PORTLAND PUBLIC SCHOOLS – FACILITY ADA ASSESSMENT

Franklin High School
August 31, 2009

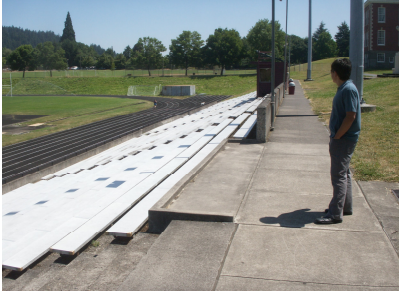
2 nd Floor Restroom, Boys 262	Existing accessible toilet stall, clearances, lavatory and accessories are installed and within reach ranges. Adjust or replace pull entry door closer to meet maximum 5 lbs. pressure and closing speed.	
1st Floor Restroom, Boys 116	Upgrade and provide accessible toilet stall, clearances, lavatory and accessories within reach ranges.	
1 st Floor Restroom, Girls 119	Upgrade and provide accessible toilet stall, clearances, lavatory and accessories within reach ranges.	
Field House, Girls	Upgrade and provide accessible toilet stall, clearances, lavatory and accessories

<p>within reach ranges. Widen and reconfigure entry and privacy partition to provide 36" clearances.</p>	
Field House, Boys	<p>Upgrade and provide accessible toilet stall, clearances, lavatory and accessories within reach ranges. Repair and add landing and ramp at entry door. Existing 6" threshold step has increased to 12" due to paving subsidence on the exterior.</p>	
Auto Shop, Girls 7	<p>Upgrade and provide accessible toilet stall, clearances, lavatory and accessories within reach ranges.</p>	
Auto Shop, Boys 9	<p>Upgrade and provide accessible toilet stall, clearances, lavatory and accessories within reach ranges.</p>	
Provide accessible toilet	<p>Provide accessible toilet, stall, grab bars, lavatory, accessories, and shower.</p>	
Provide accessible toilet	<p>Provide accessible toilet, stall, grab bars, lavatory, accessories, and shower.</p>	
Drinking Fountains	<p>Verify that at least one corridor DF on each floor and in each building complies with clearances. Preferred locations are near upgraded restrooms.</p>
